Replace Front Fender Garnishes

Classification	Repair Bulletin	Section/Group	12 - Exterior Fittings	Country/Region	United States
Year	2016	Model	Model X	Version	All

Figure 1

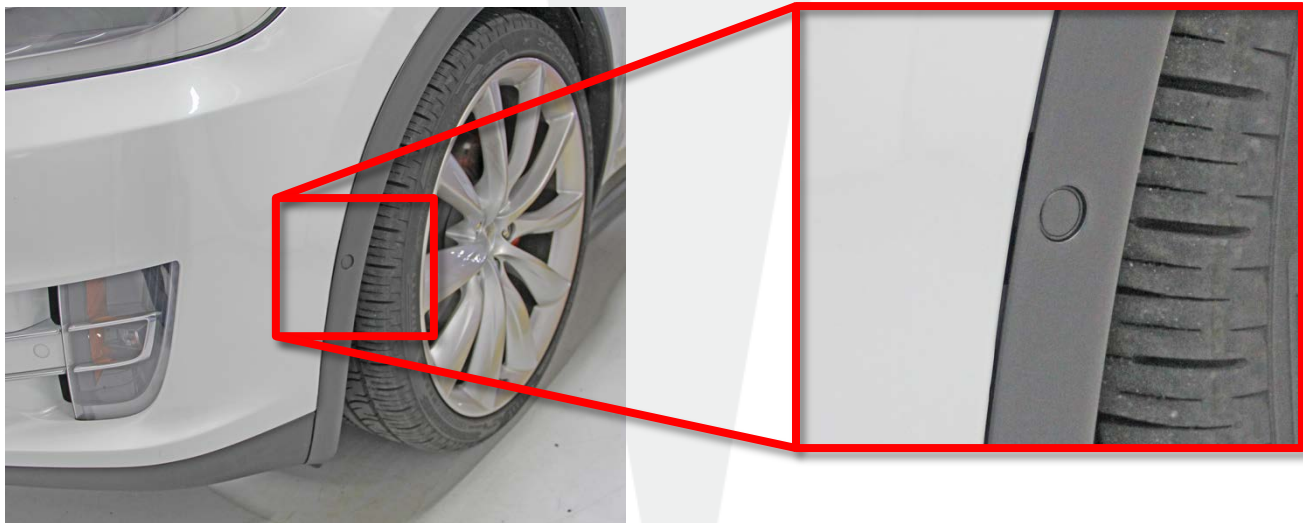
The parking sensors might not be flush with the front fender garnishes (Figure 1) on some Model X vehicles, causing a perceived quality issue.

Upon customer complaint, replace both front fender garnishes.

2. Ensure that the parking sensor is flush with the new fender garnish.
3. Install the new front fender garnish.
4. Perform steps 1-3 on the RH side of the vehicle.
